M2PP-121-D-PLNM-0003

Site Specific Management Plan 003 - [sectors 360/370/380]  
MacKays to Peka Peka Expressway

01 SEPTEMBER 2014 - CERTIFIED ISSUE - REV C

## SITE SPECIFIC MANAGEMENT PLAN - WHAREMAUKU BASIN [SSMP 3 - SECTOR 360, 370, 380]

Title:	SSMP 3 - SHEET 28 TE ATIAWA COLUMN DESIGN
--------	--

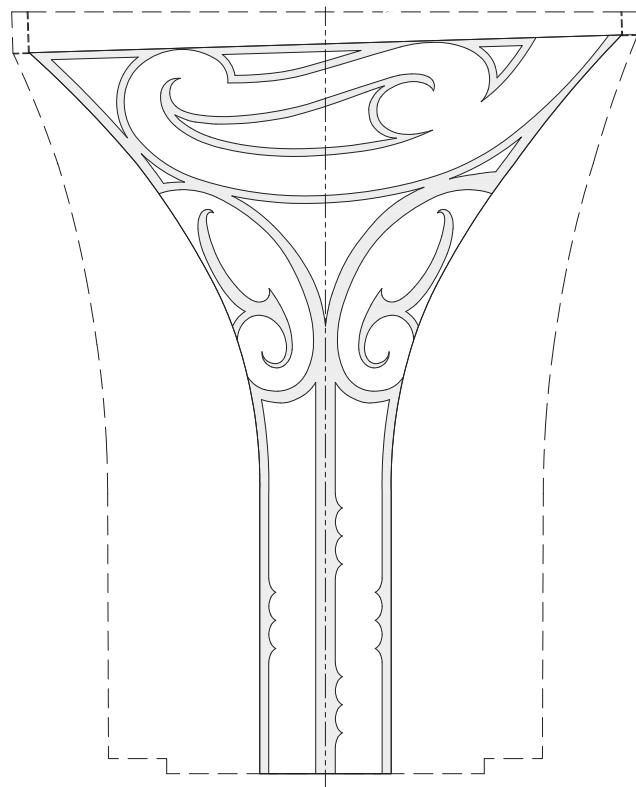
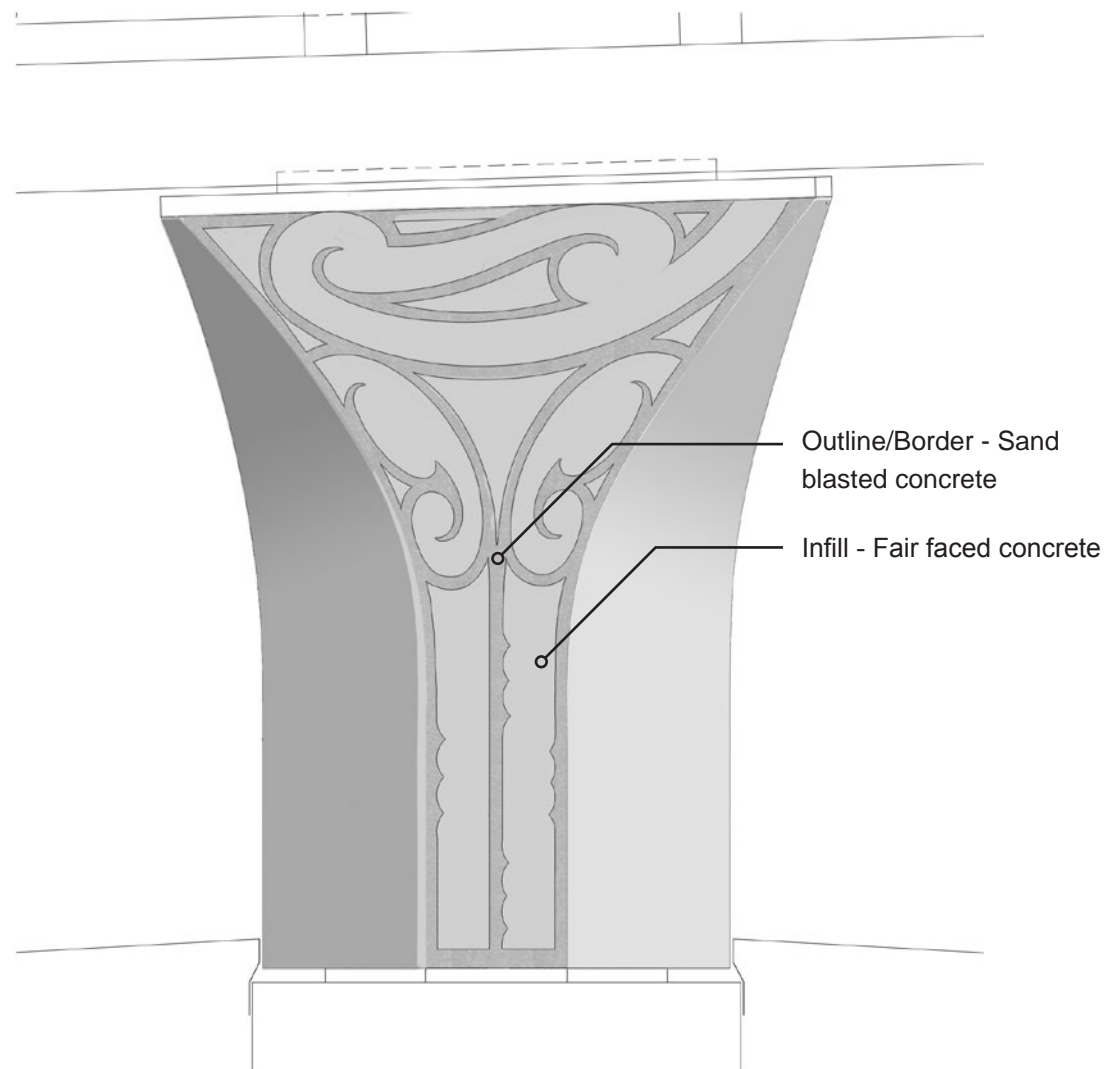
SSMP 3 SHEET 28 - Type 1 CWB entrance detail	M2PP-121-D-DWG-8802	New Sheet added	A	CWB entrance structures- design change to precast units. To replace Type 1 on sheet 18	KCDC		3.5.16
SSMP 3 SHEET 29 - Te Atiawa Column Design	M2PP-121-D-DWG-8803	New Sheet added	A	Page added to illustrate Te Atiawa design to be applied to Kapiti bridge columns (sand blasted etching)	KCDC		3.5.16

Title: KAPIHI ROAD INTERCHANGE PLANTING PLAN SHEET 1

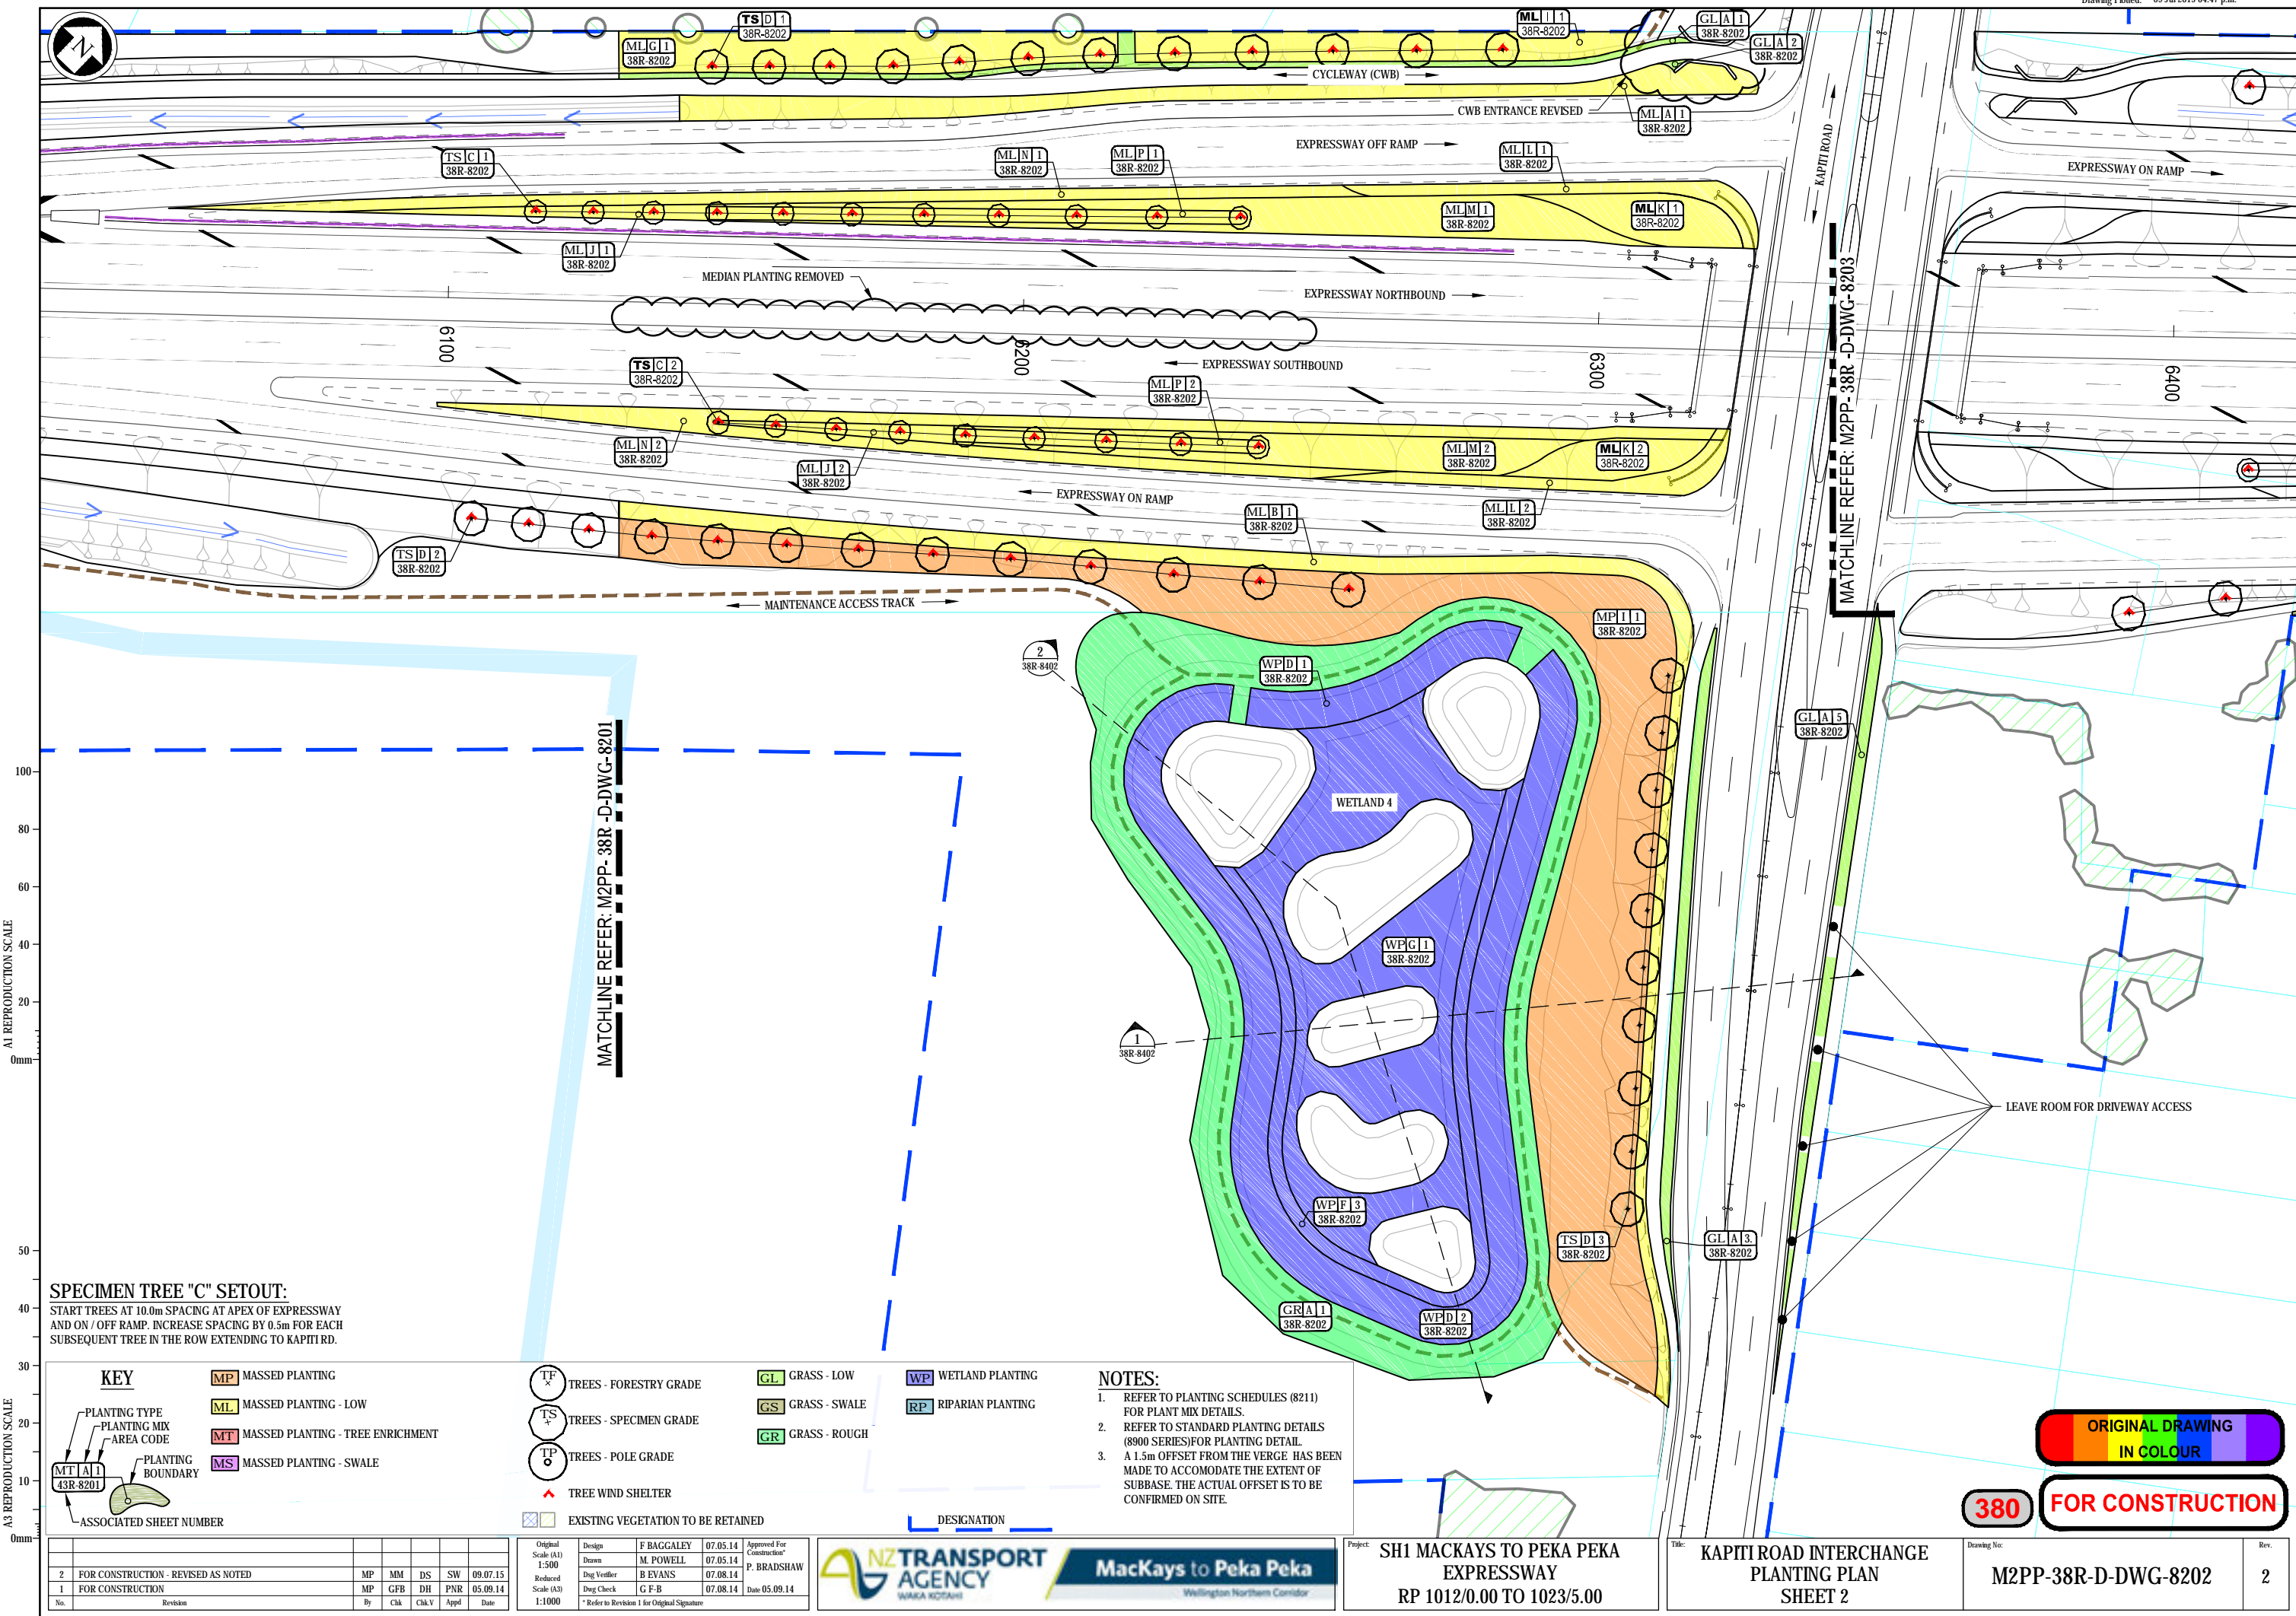
SHEET 26 - CWB sign type summary	M2PP-121-D-DWG-8901	Revision/Update	D	Signs updated to include horse symbol- All CWB signs to be updated as per this sheet	KCDC		3.5.16
Kapiti Road interchange planting plan SHEET 1	M2PP-38R-D-DWG-8201	Revision/Update	2	Removed planting in median strip (supersedes all other drawings that may show planting)	KCDC		3.5.16
Kapiti Road interchange planting plan SHEET 2	M2PP-38R-D-DWG-8202	Revision/Update	2	Removed planting in median strip (supersedes all other drawings that may show planting)	KCDC		3.5.16
Kapiti Road interchange planting plan SHEET 3	M2PP-38R-D-DWG-8203	Revision/Update	2	Removed planting in median strip (supersedes all other drawings that may show planting)	KCDC		3.5.16
Kapiti Road interchange planting plan SHEET 4	M2PP-38R-D-DWG-8204	Revision/Update	2	Removed planting in median strip (supersedes all other drawings that may show planting)	KCDC		3.5.16

AEE PLAN- WHAREMAUKU STREAM BRIDGE - 1:500@A3

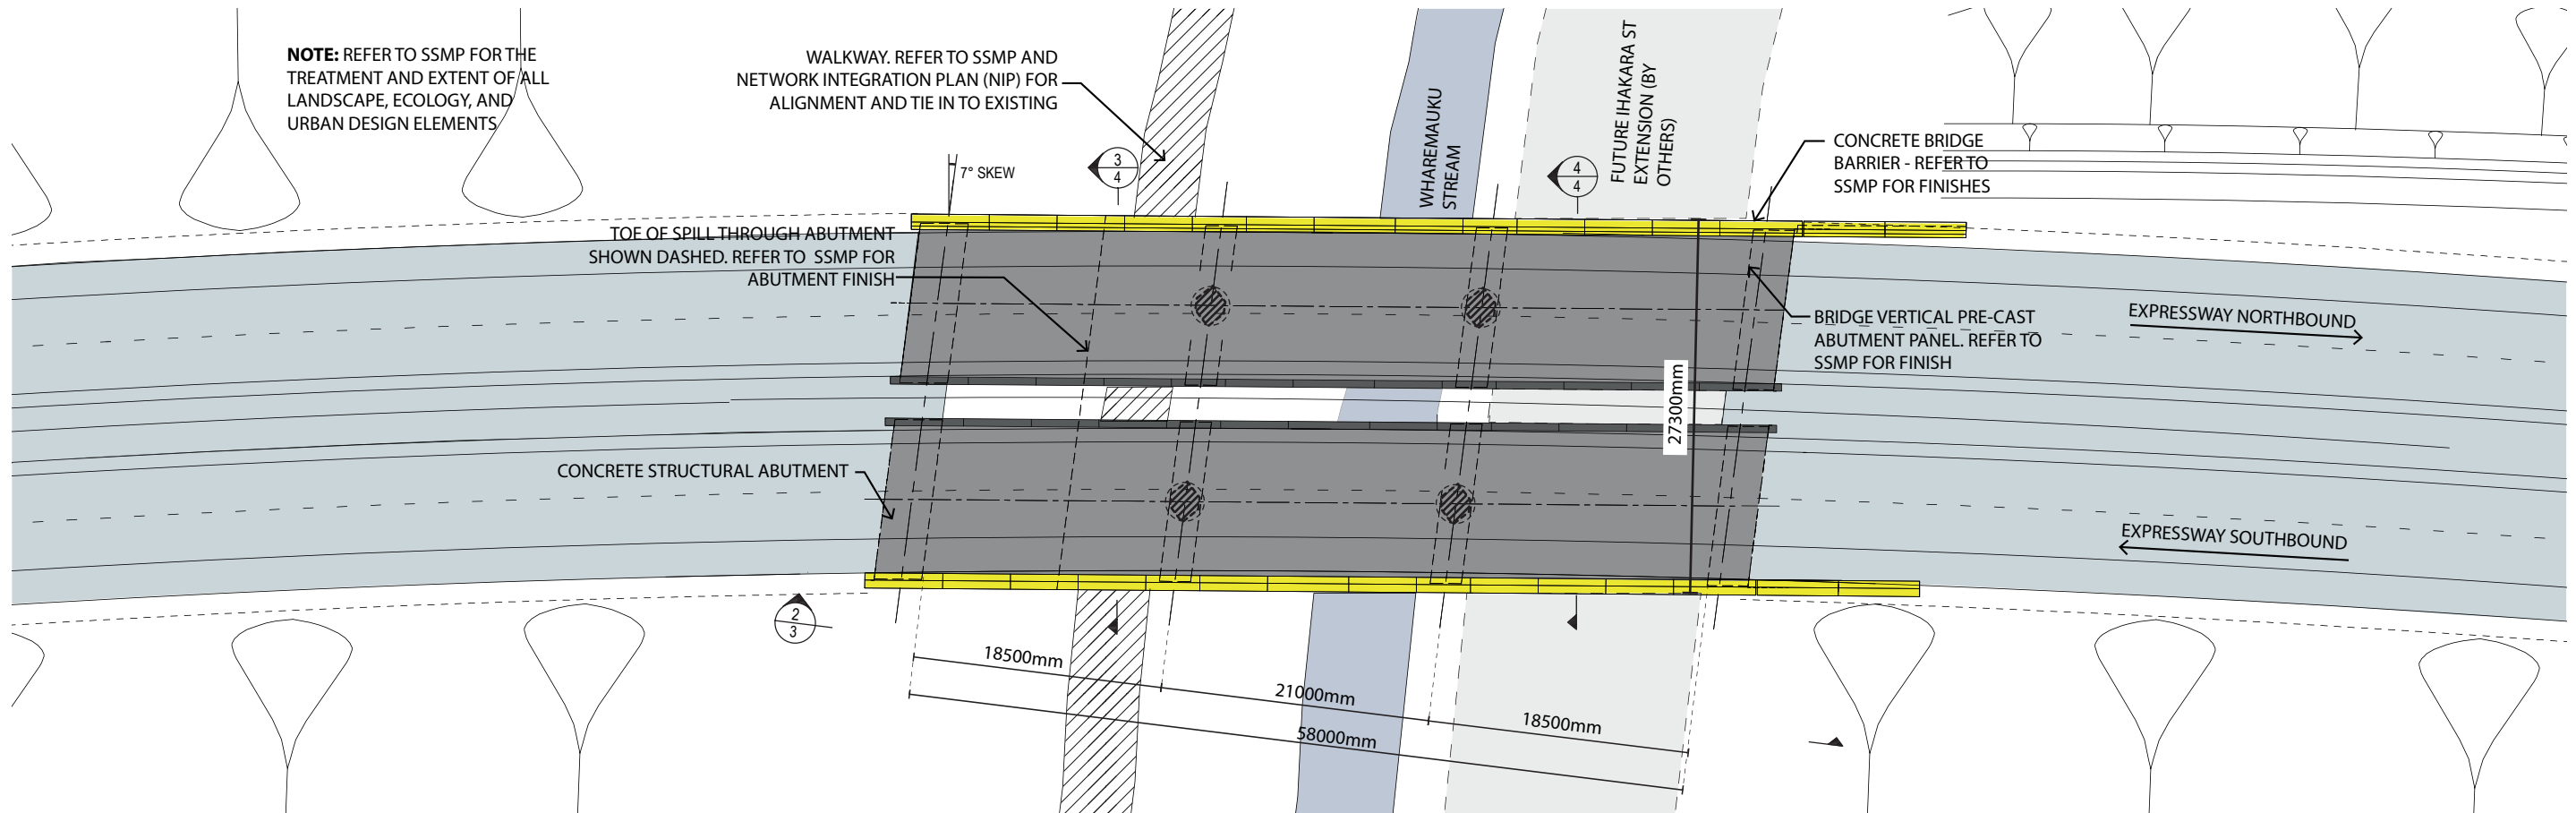
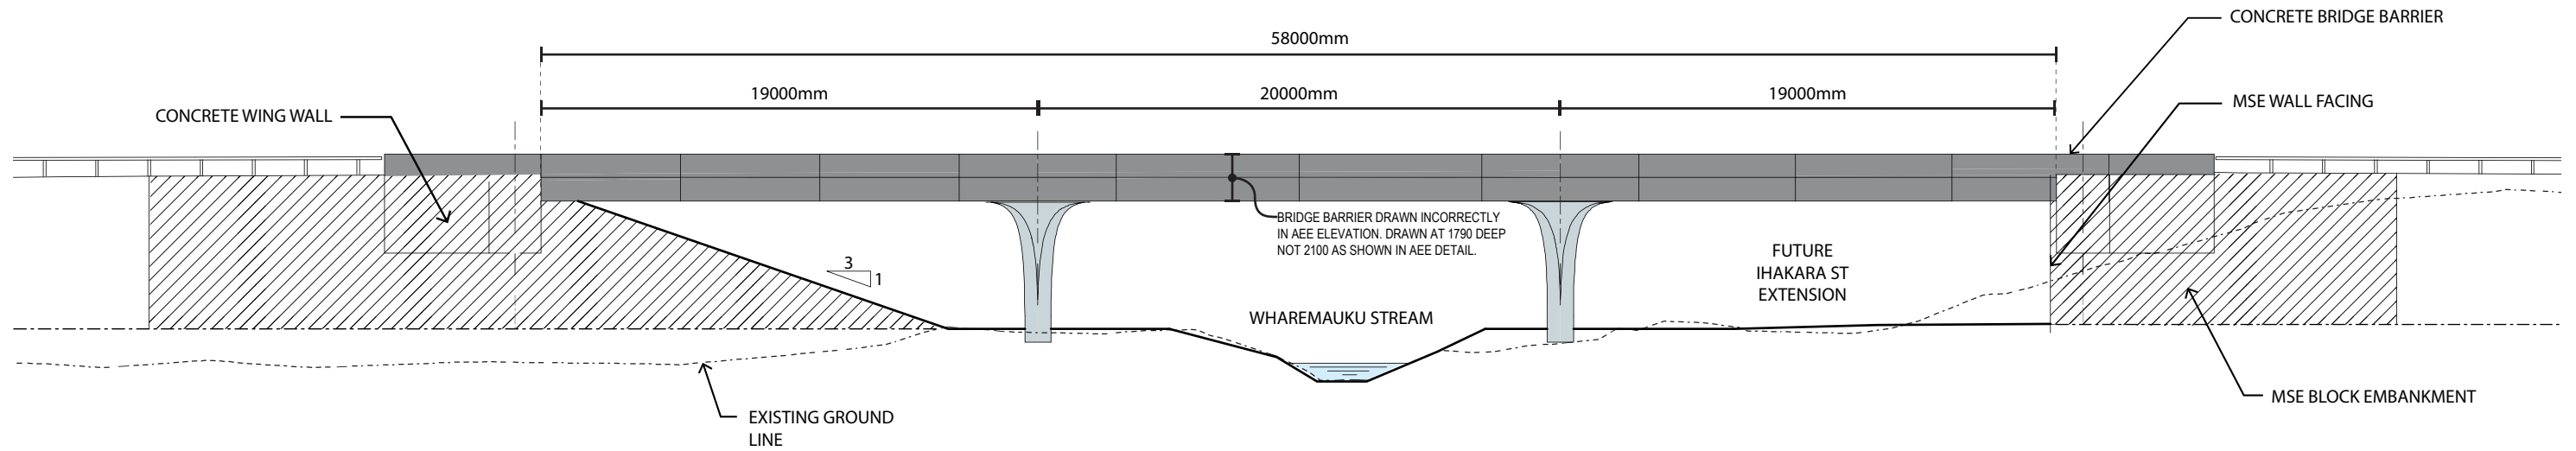
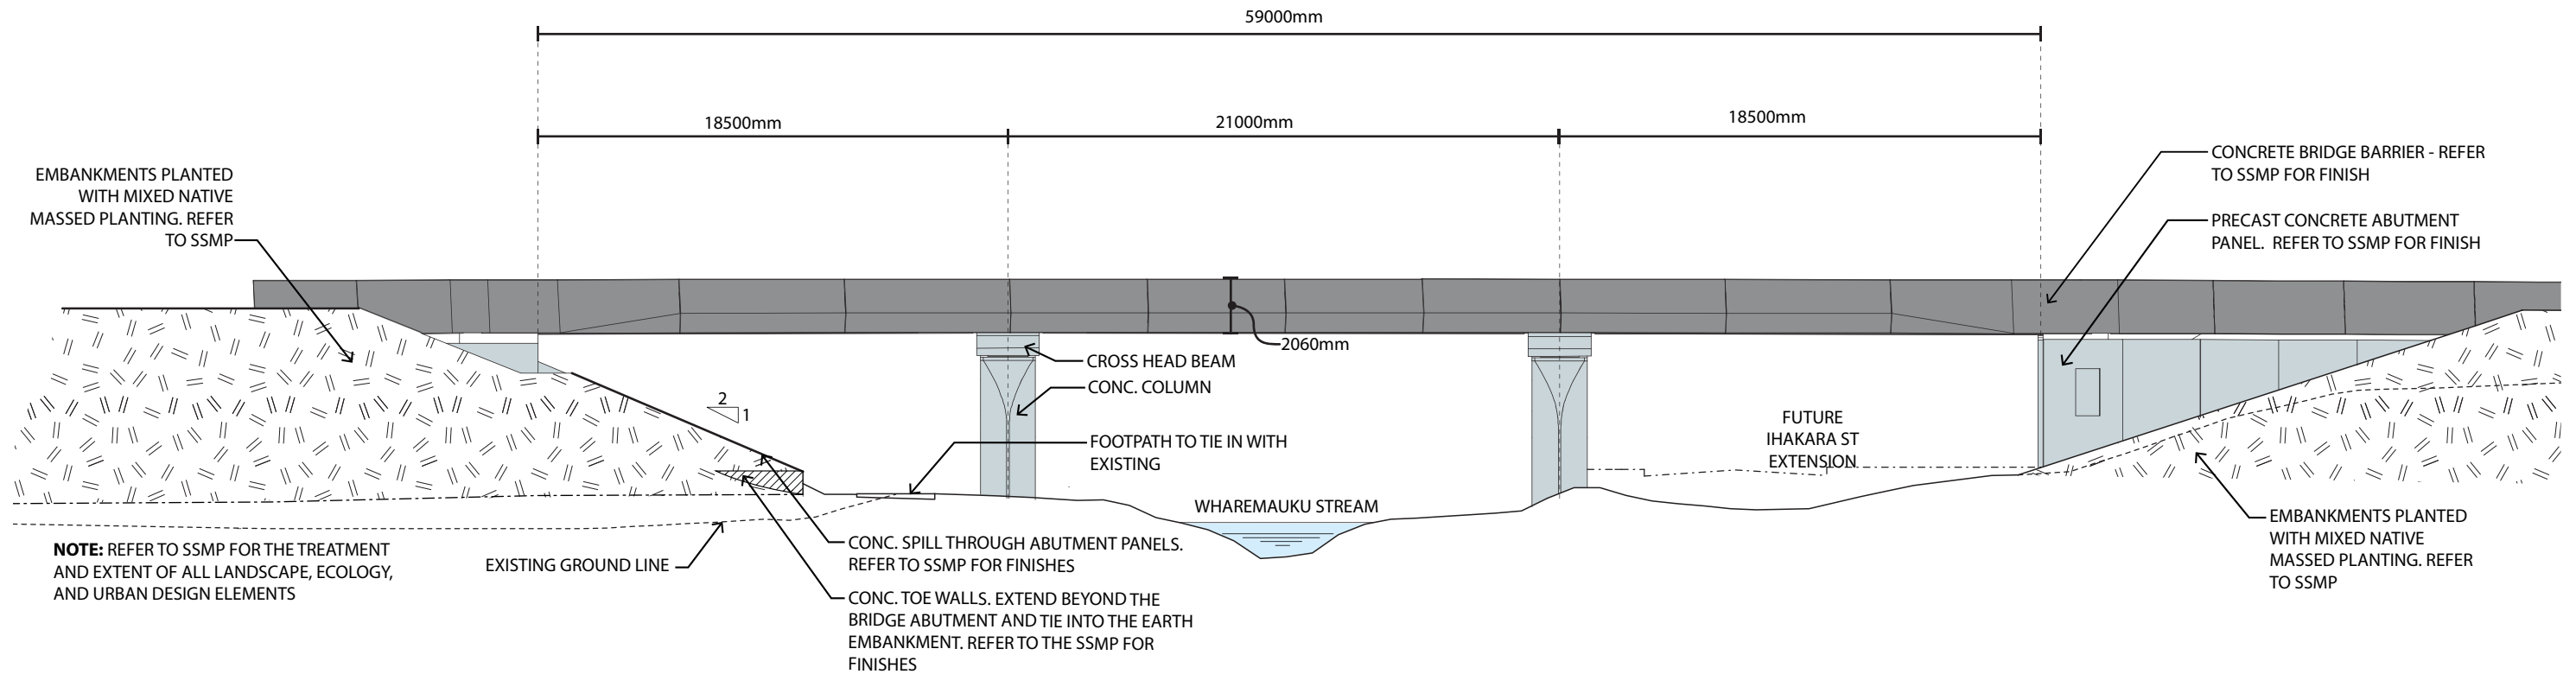
1. Column shape and location changed, abutment details refined

1. Reduced number of columns (8 to 4) Due to bridge skew will appear more open beneath
